HIGH SCHOOL #2
OLD RIVER ROAD AT
MCCUTCHEN ROAD

KERN HIGH SCHOOL DISTRICT
BAKERSFIELD, CALIFORNIA

SITE ELECTRICAL PLAN

SHEET TITLE
UTILITY PLAN

SHEET IDENTIFICATION NUMBER
C7R
SHEET 7 OF 23

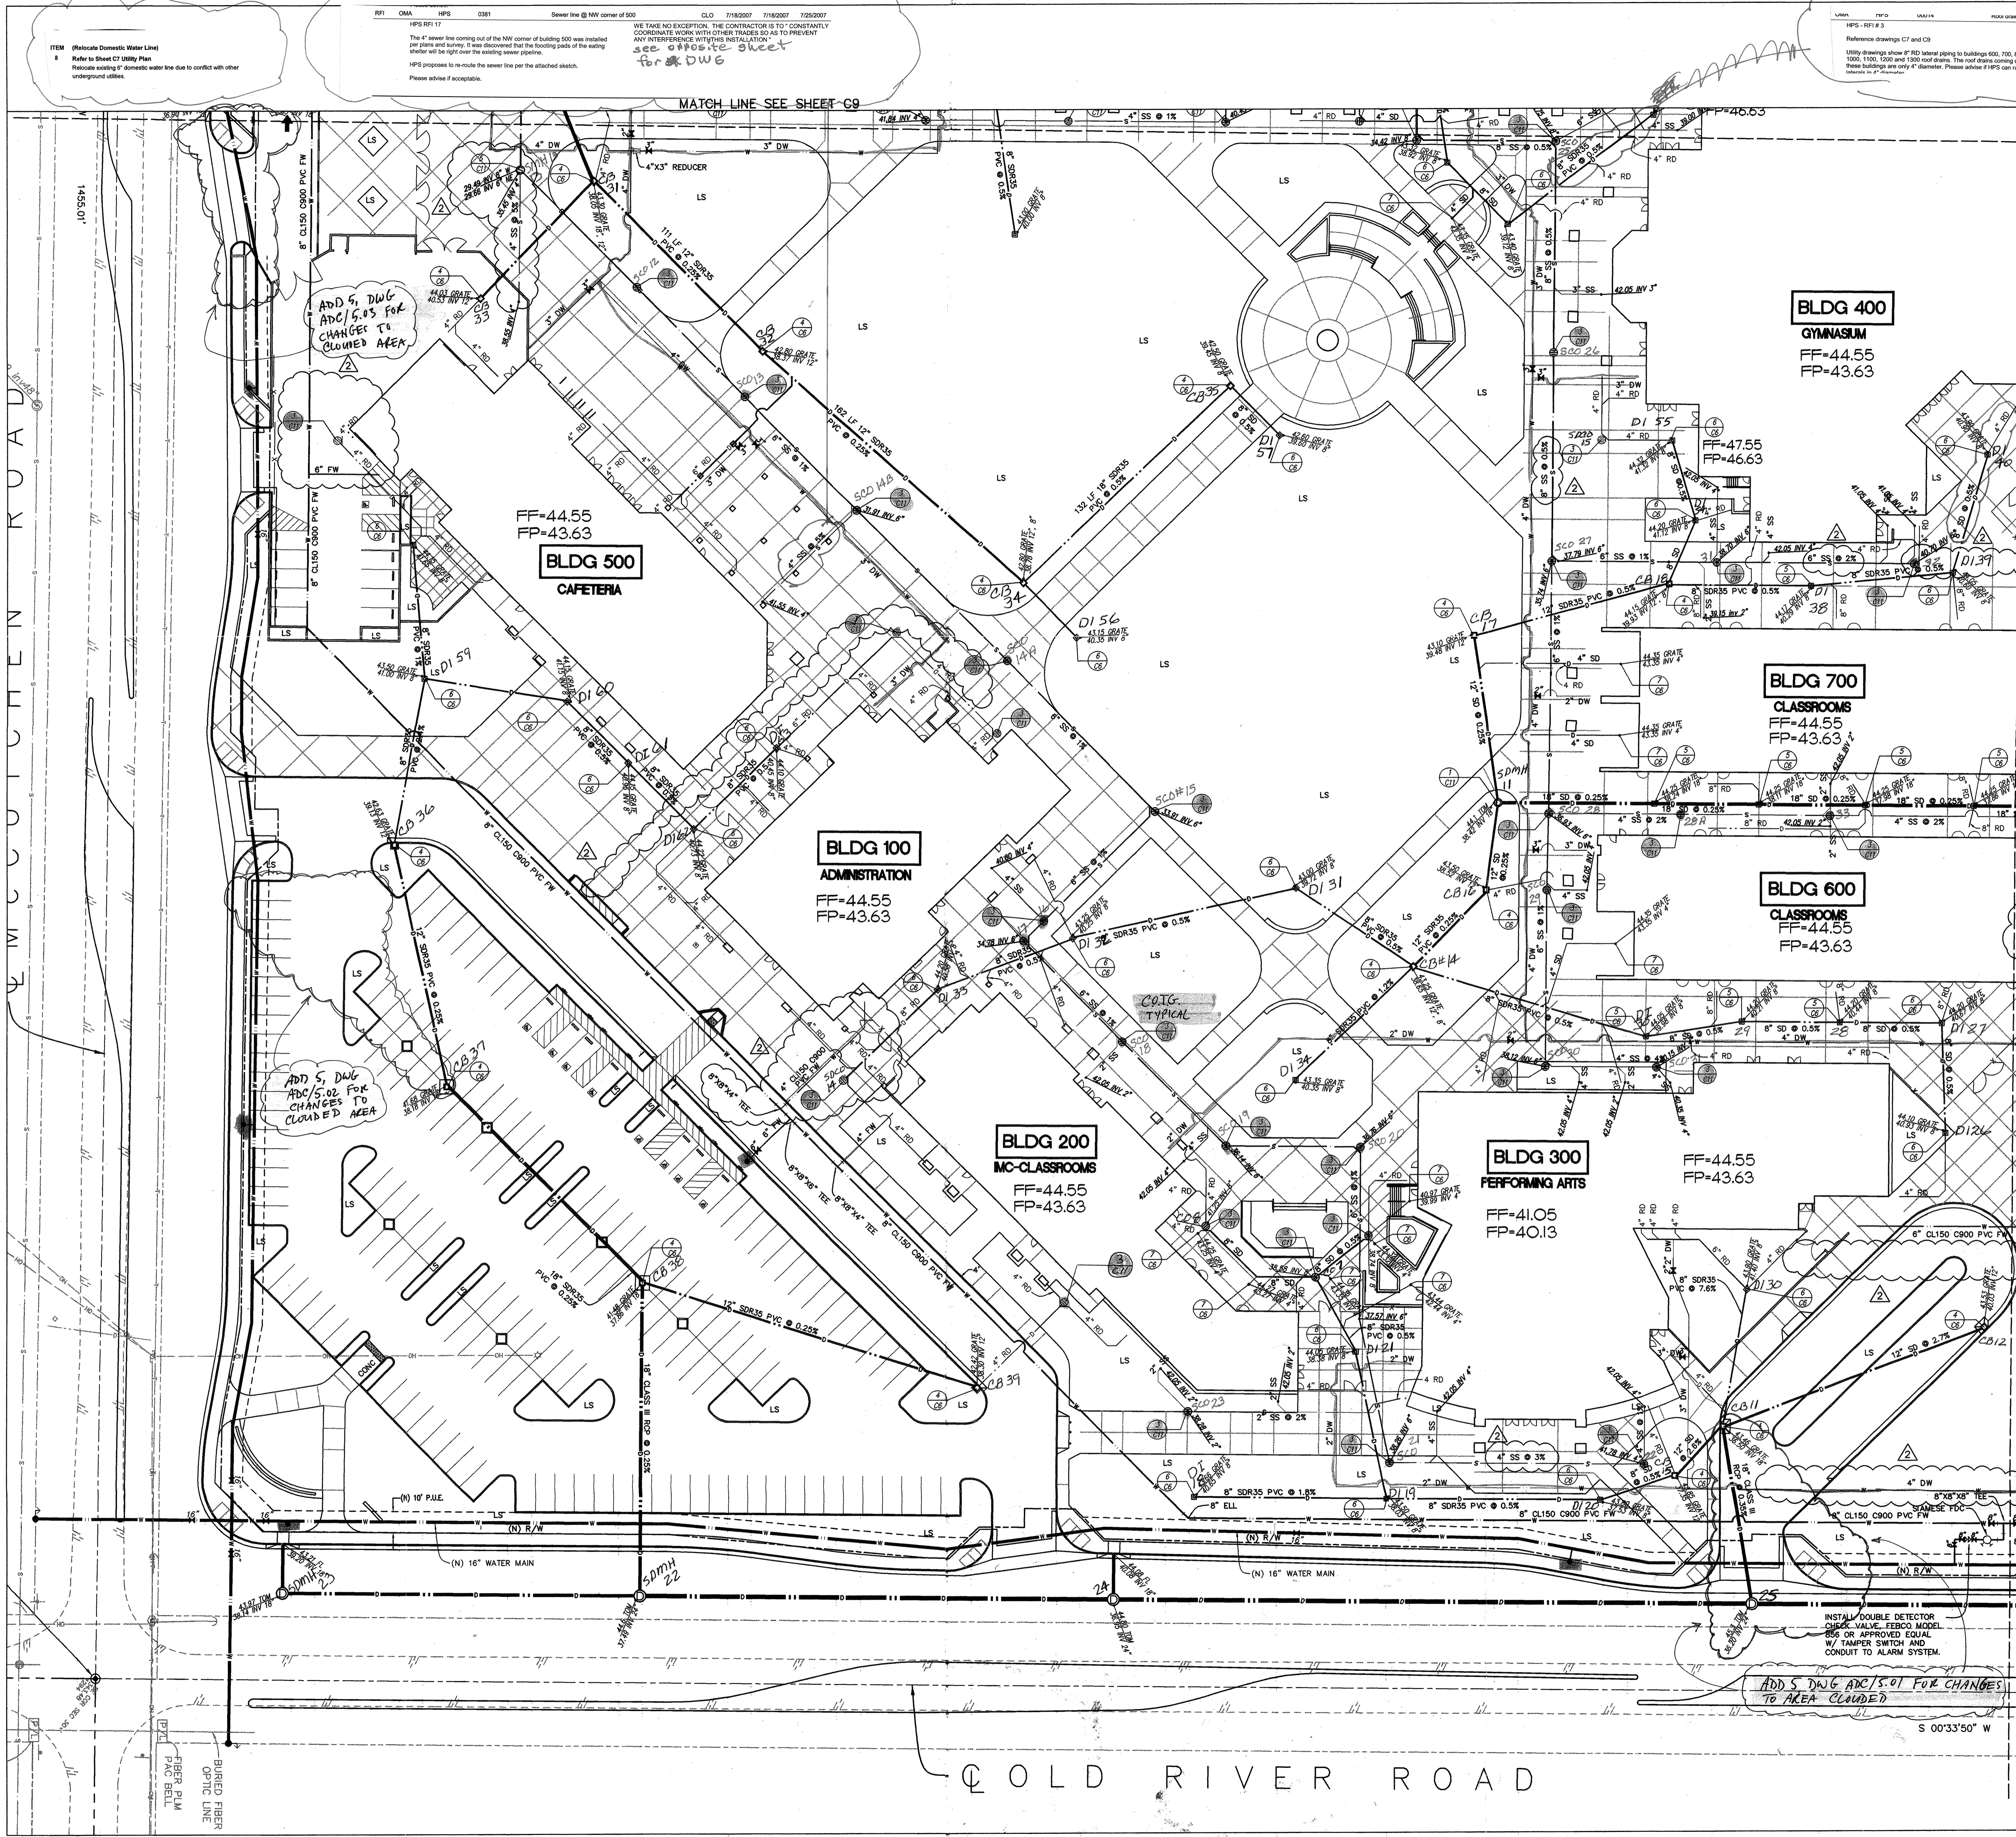
ITEM (Relocate Domestic Water Line)
Relocate existing 8" domestic water line due to conflict with other underground utilities.

NOTE:
The 4" sewer line coming out of the NW corner of building 500 was installed per plans and survey. It was discovered that the footing walls of the existing sewer will be right over the existing sewer pipeline.
HPS proposes to re-route the sewer line per the attached sketch.
Please advise if acceptable.

NOTE:
THE 4" DIA. LATERALS IN QUESTION PICK UP TWO 4" DIA. ROOF DRAIN DOWNSPUTS AT EACH LOCATION. THE CONTRACTOR IS TO TIE THE TWO 4" DIA. DRAINS INTO THE 4" DIA. LATERALS. IF THE CONTRACTOR WOULD PREFER TO RUN TWO 4" DIA. LATERALS, INSTEAD OF ONE 4" DIA. LATERAL, TO TIE INTO EACH 4" DIA. ROOF DRAIN.

ADD S.DWG. AND S.O.I. FOR CHANGES TO AREA CLOUDED

ADDENDUM #2
IN ADDITION TO THE CLOUDED CHANGES, THE FOLLOWING ITEMS HAVE BEEN ADDRESSED AS A PART OF THIS ADDENDUM:
ADDITION:
1. ALL ROOF DRAIN LATERAL SIZES AND LOCATIONS FOR EACH BUILDING.
2. SEWER LATERAL INVERT ELEVATIONS AT ALL BUILDING POINTS OF CONNECTIONS.
CHANGE:
1. ALL STORM DRAIN PIPE LARGER THAN 24" SHALL BE CLASS III RCP WITH RUBBER GASKET JOINTS.
2. SEWER MAIN INVERT GRADES.

INSTALL DOUBLE DETECTOR CHECK VALVE, FERCO MODEL 865 OR APPROVED EQUAL W/ TAMPER SWITCH AND CONDUIT TO ALARM SYSTEM.
